Free wheel pulley alternator  
Change design

FAPU Kit

VKM 03612

### Free wheel design upgrade:

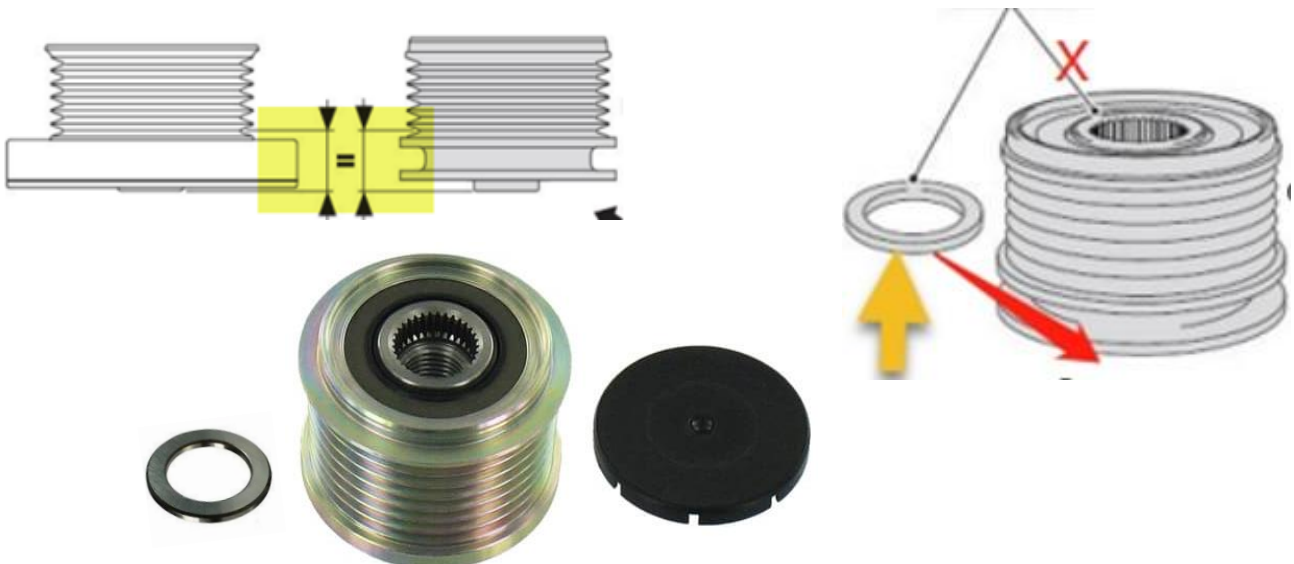
- Due to design standardization, here is our proposal completely interchangeable with the old one.
- Based on customer requirements, a cap has been added to avoid dirt, and a ring (put on the bottom), to increase the first slot distance of OAP
